## The design and construction of the Calder Bridge on the M1 motorway

E. W. H. GIFFORD, M. V. WOOLLEY & A. A. W. BUTLER

**Fig. 20. Designs for the Calder Bridge competition**

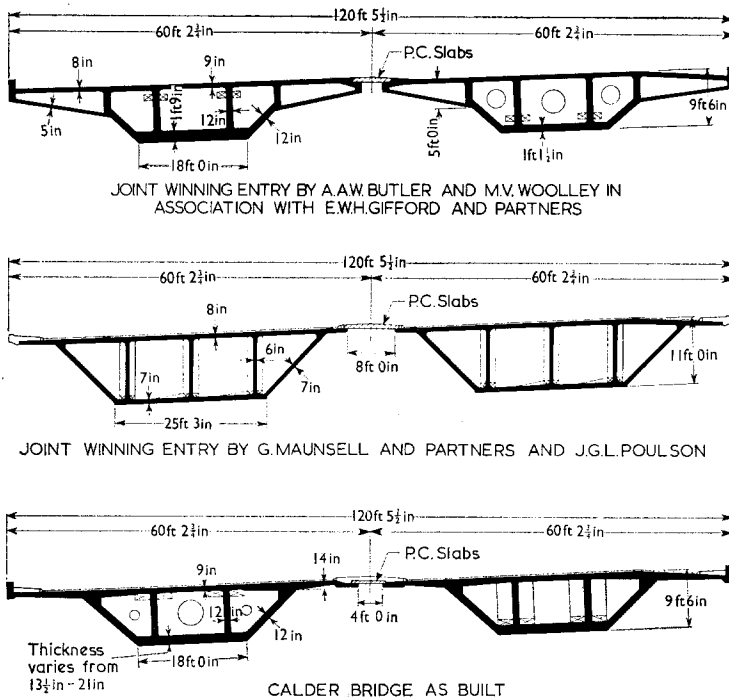
101. I should like to say a few words on the subject of the original Calder Bridge competition. The competition brief posed interesting technical problems and in my opinion a straightforward solution of the problems outweighed considerations of startling appearance. As it turned out, the judges were not able to recommend a clear winner and recommended that the first prize be divided equally between the Authors' design and one prepared by my firm. The two winning designs had quite striking similarities, the main difference being that the Authors' design had three spans whereas the Maunsell/Poulson design relied on a simple span supported on three bearings, two on one side and one on the other. Fig. 20 shows at the top the design which the Authors submitted for the competition. Below it is the Maunsell entry and at the bottom is the structure as built. It can be seen that there has been considerable development of ideas, indeed almost a hybrid section has been evolved from

the winning entries. I would like to ask the Authors if they revised their scheme themselves or were requested to do so by the Client—perhaps either the Ministry of Transport or the West Riding County Council.

187. **Mr Lee's** first point concerned the difference between the Authors' competition design and the final design as it emerged. We were not prompted in any way to alter the design, but the alteration resulted from the opportunity to consider the problem in depth. It also sprang from a more accurate evaluation of the aesthetic problems in relation to the cost of the project. The deck cantilevers were originally

cellular in form (a rather expensive form of construction) and they were associated with diaphragms at about 30 ft centres throughout the bridge.

188. The main reason for the original choice of design was that it was felt that the slab size appearance presented by the long sloping web (which is a feature of the final design) was unacceptable. We subsequently decided that the structural complication and extra cost of the original solution was not justified.

189. The elimination of the cellular cantilevers, and substituting the simple slab cantilevers of this form in the final design, greatly simplified the whole design and, in particular, eliminated the diaphragms, which was a great simplification in construction.

Fig. 21. Temporary supporting beams of the spans

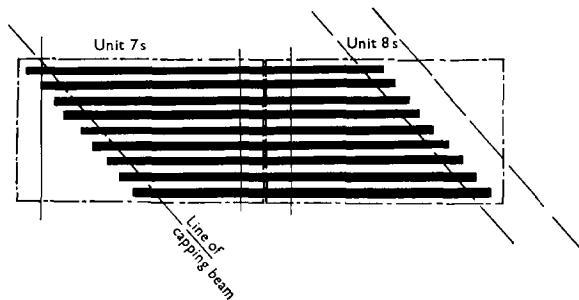
105. The temporary supporting beams of the spans were running along the lines illustrated in Fig. 21. There were nine of them covering the width from one side to the other. When the units were cast, they were cast square to the bridge and, of course, the ends of them were skew relative to the supports of the beams. The supports provided by the capping beams were parallel with the river.

106. We thus have the situation that if one considers the strength of the supporting beams relative to the end of any particular 220 ton unit, each supporting beam would provide a deflexion or effective apparent stiffness varying from that of its neighbours, which meant that each unit was subject to a rotation about an axis which was skew to the bridge, skew to the river, and skew to practically everything.

Fig. 23. Skew plan

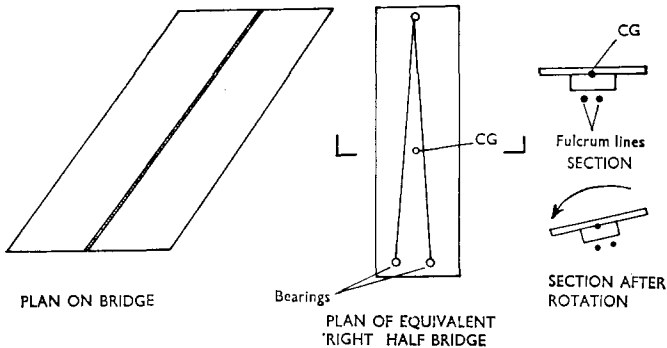
155. If one could briefly show that in the skew span, shown in Fig. 23, which was divided into the two half bridges with the bearings in their relative positions, and then isolating diagrammatically one of these half bridges and calling it a right bridge for the moment to illustrate the point, we are then faced with the Authors' fulcrum lines which are very slender indeed and very finely spaced. If one takes a section through the centre of gravity, and in that section one has the bridge and its centre of gravity and if one has these two fulcrum lines at quite a small distance apart, I know that I am exaggerating, but so also can mining subsidence exaggerate itself. It does not need much of a rotation before the bridge is head over kilter. Therefore, I query where the 4 ft and the 1 ft 6 in. originated and in doing so I suggest that the figures are something of a guess. It is all very well if subsidence is continuous (it is possible to jack) but in the event of sudden subsidence, which is possible in certain overburden, one could be in difficulty.

157. Why did not the Authors put in a statically determinate jacking method? They have four jacking points per pier. Why not three? This makes life easier. The jacks have to supply two conditions. They must strain equally, and they must have equal load on them. These are two independent conditions not easy to arrive at.
